- A. 7-Eleven Gas Station - 1650 W. Algonquin Rd. - PC#18-026
Special Use Permit for Auto Service (Gas) Station, Variation

File Number: PC 18-026
Project Title: 7-11 Gas Station
Address: 1650 W. Algonquin Rd.
PIN: 08-08-401-028

Case Number: PC 18-026

AS1.01

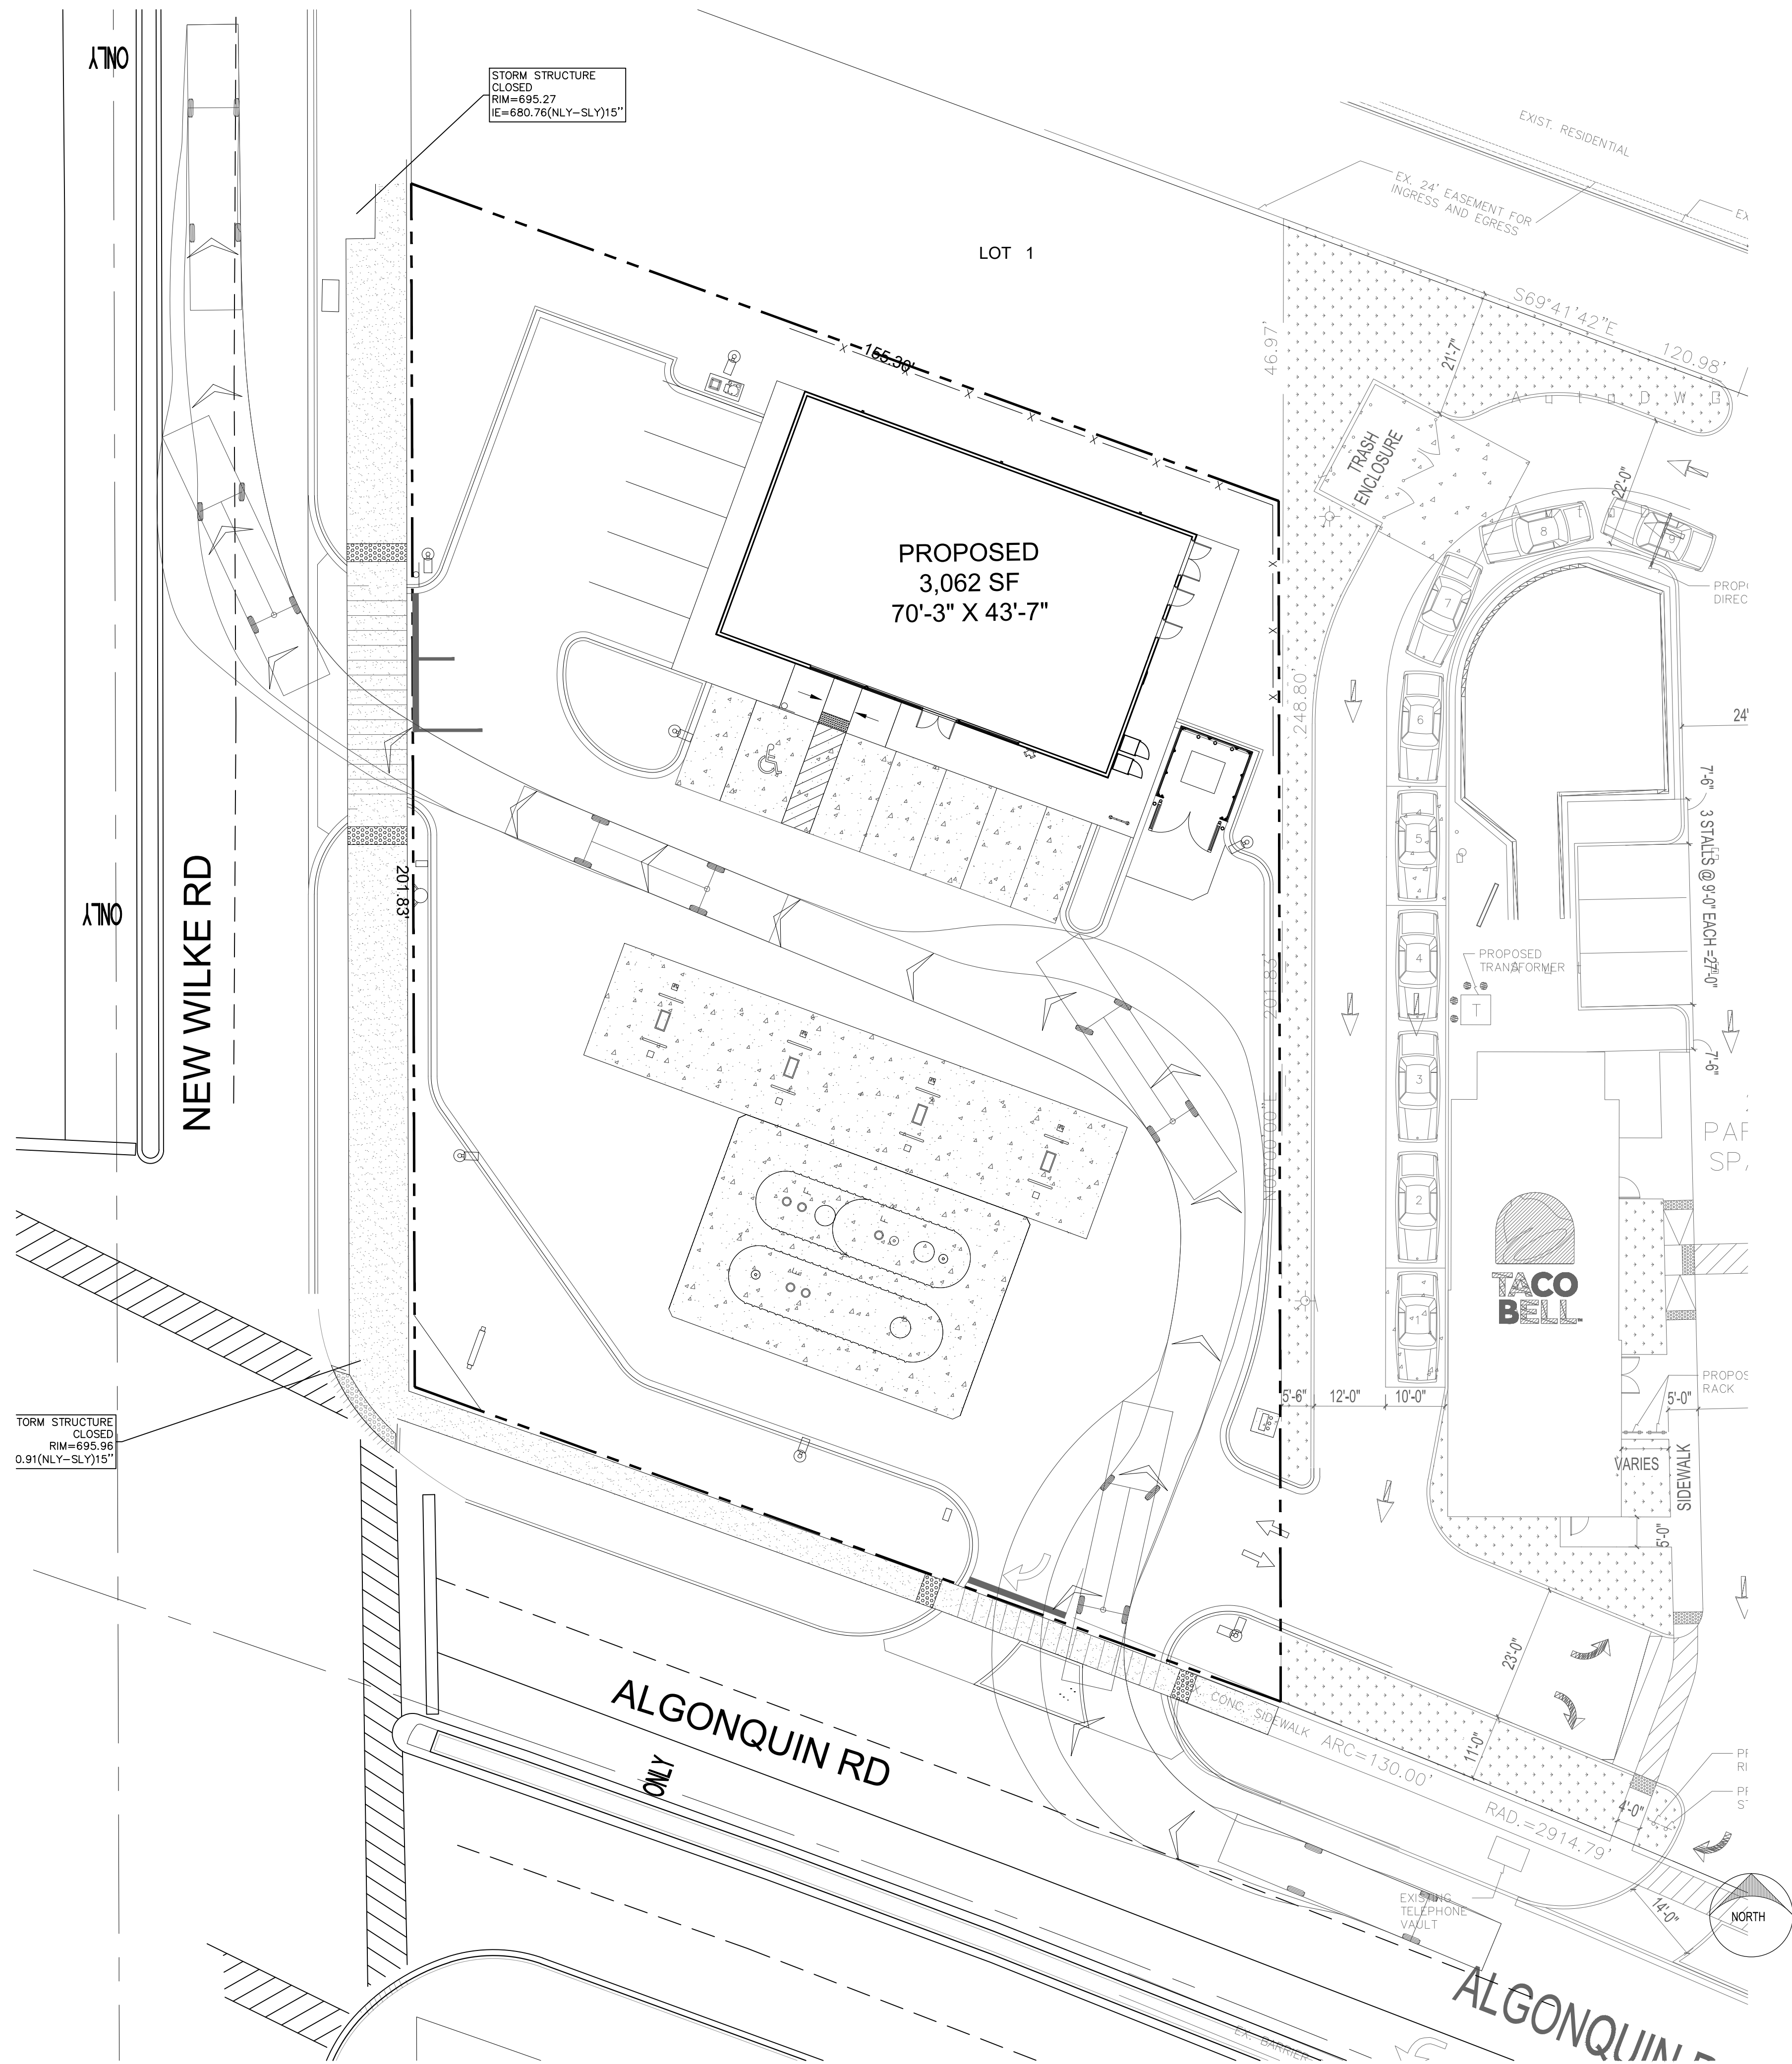
15. Please complete the site analysis table with the proposed building setbacks on sheet AS1.01 as well as the proposed impervious surface coverage and FAR info on the "Site Data" table on sheet C-2.

Response: Please refer to sheet AS1.01 for updated table.

A2.01

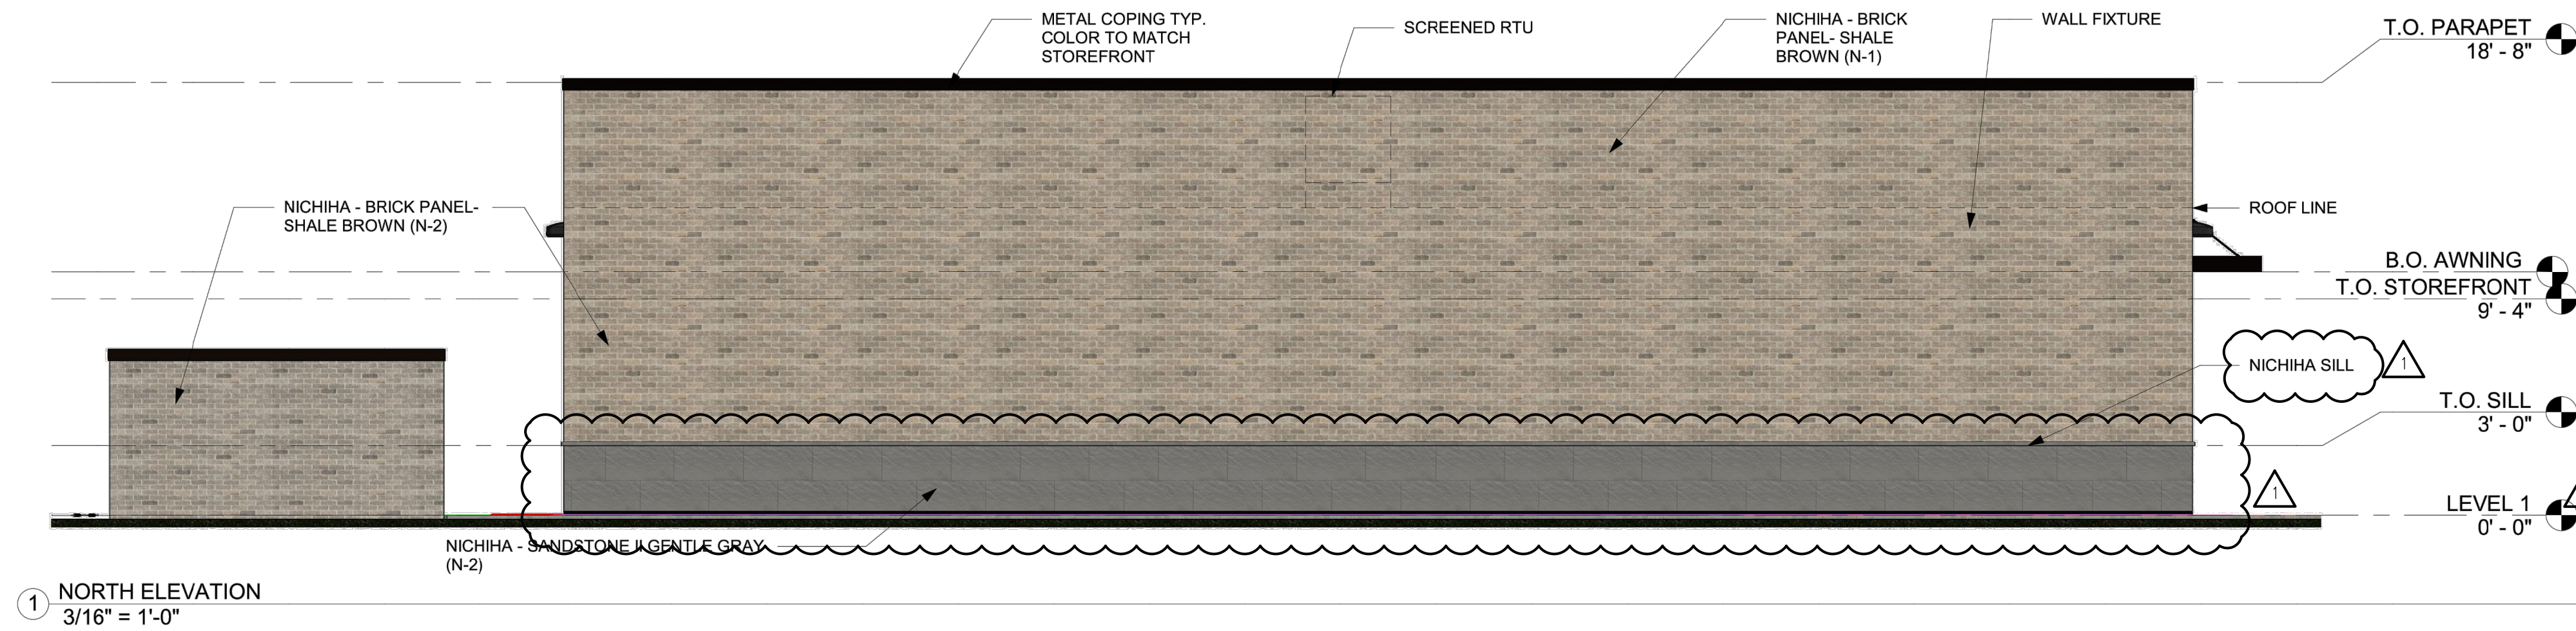
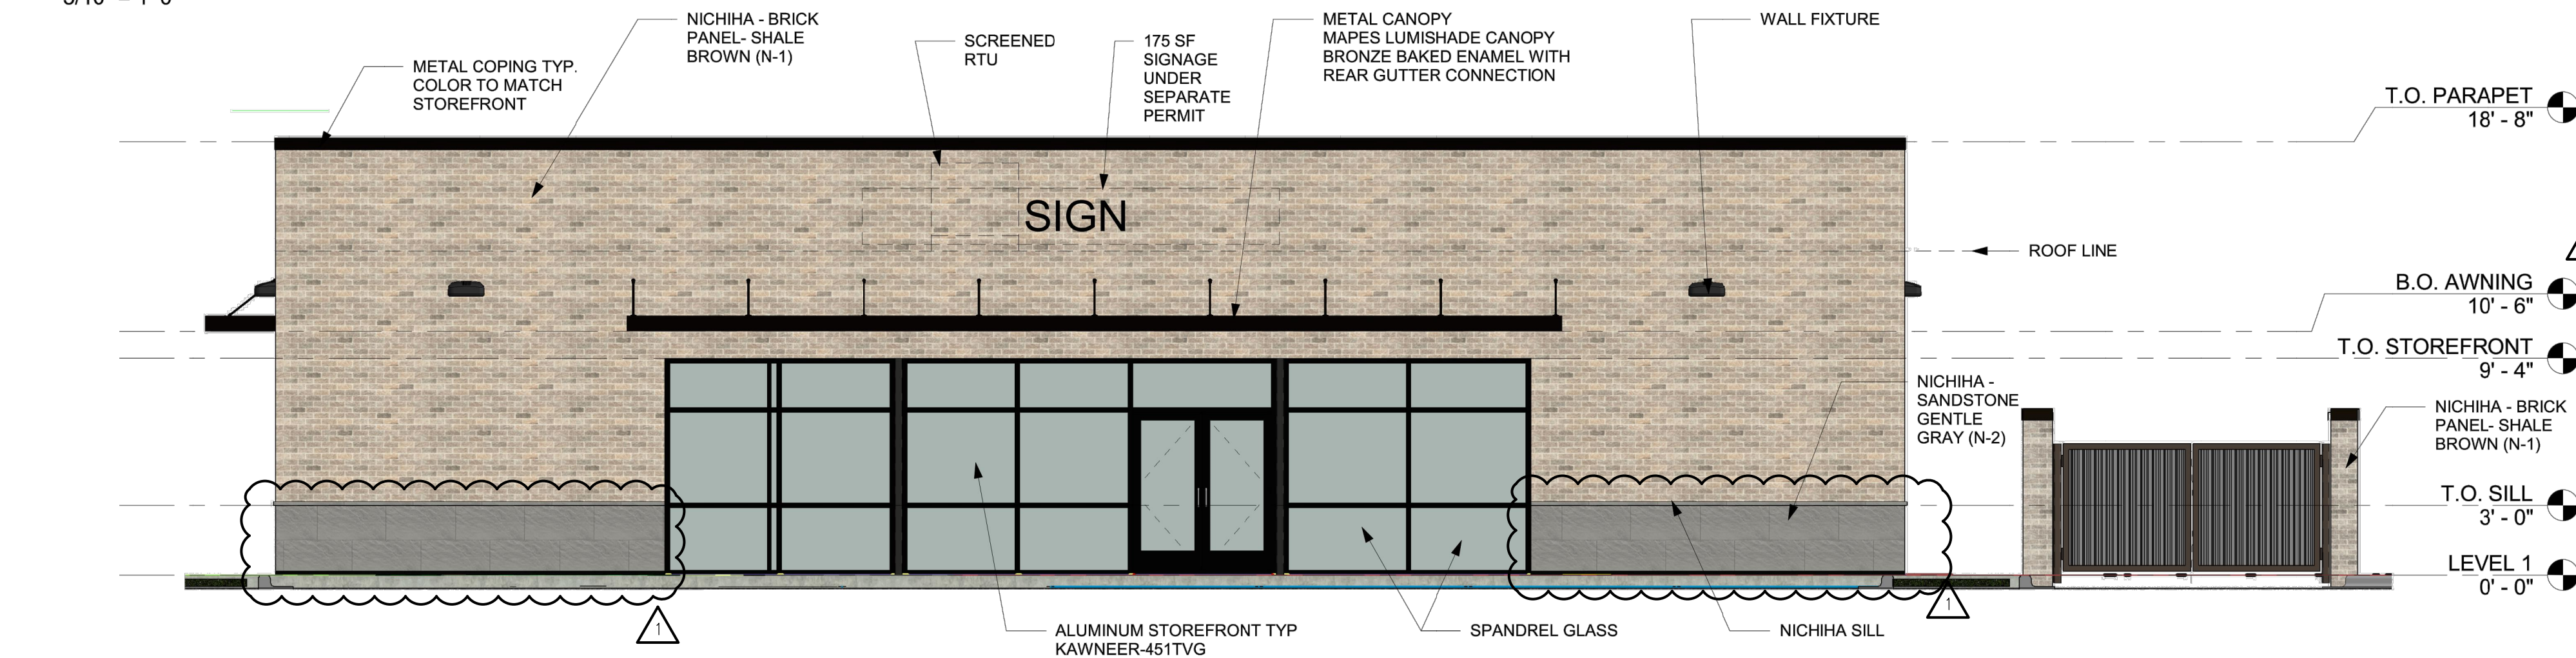
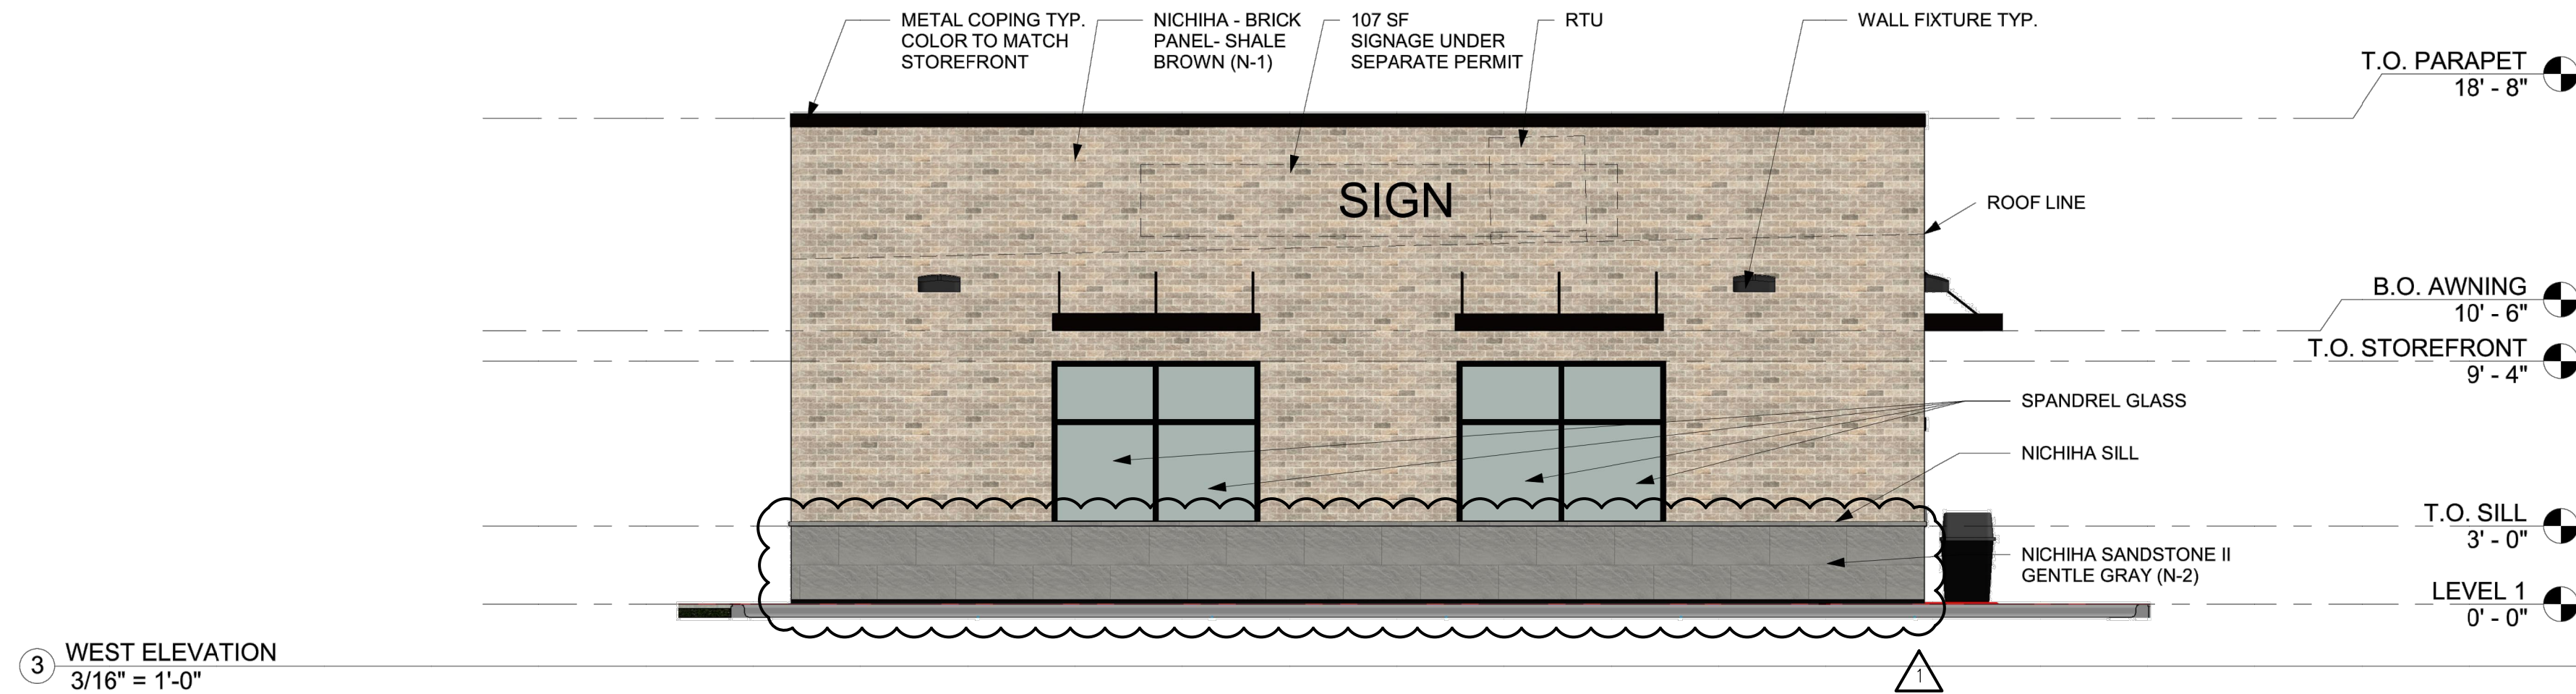
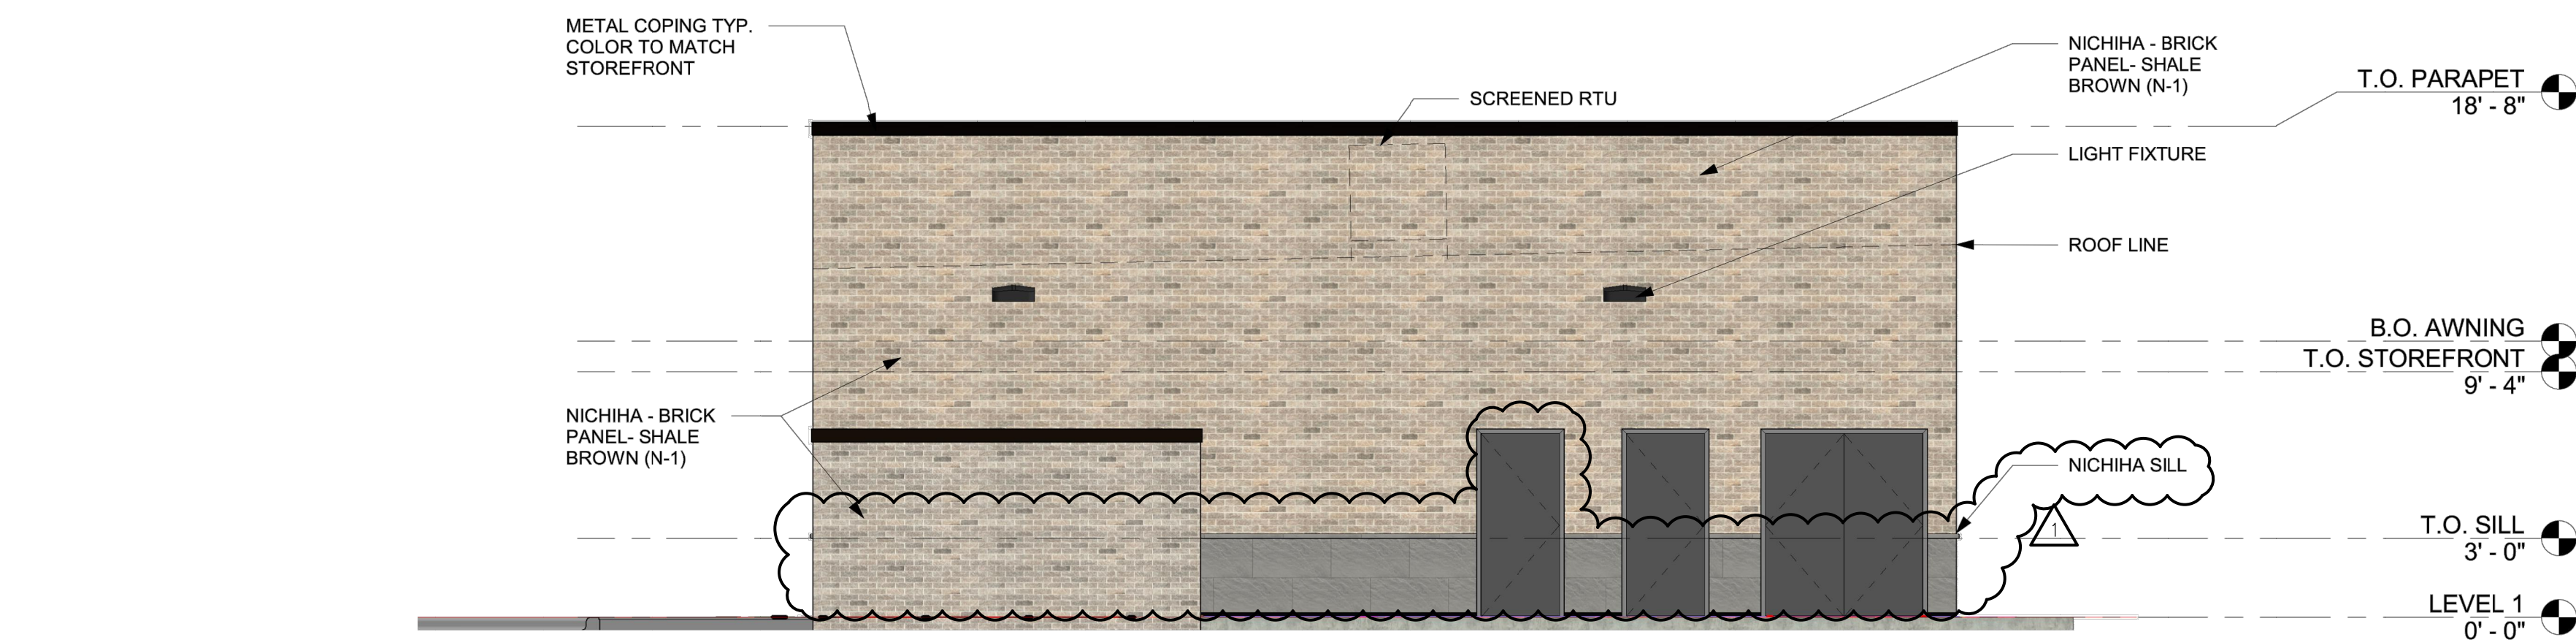
- The flush transition between the fiber cement “stone” base panels and the upper fiber cement “brick” wall panels looks too flat and has a fake appearance. It is recommended that a projecting sill trim piece be included between the two materials for a more authentic appearance. Consider using an adhered cultured stone sill detail.
- The stone base panels on the trash enclosure and canopy columns have a heavy appearance. Consider omitting the stone panel details on these items, providing an all brick appearance.

Mr. Nockov said that they agree with the suggestion to add separation between the brick and stone; however, they need to confirm with the manufacturer about how it can actually be done.

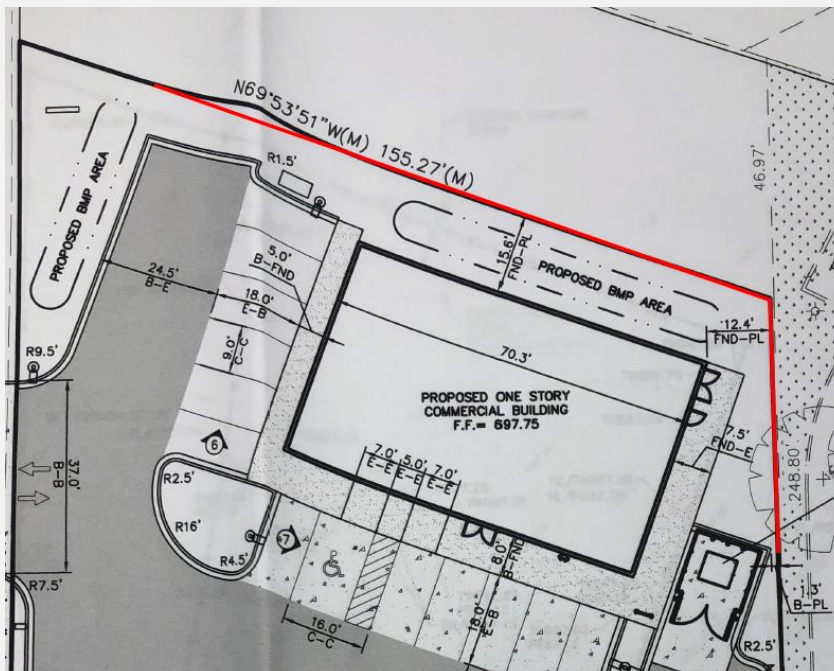
along the west, southwest, and south as far in as possible while still preserving adequate space for vehicular access and circulation. Please see the exhibit below for clarification.
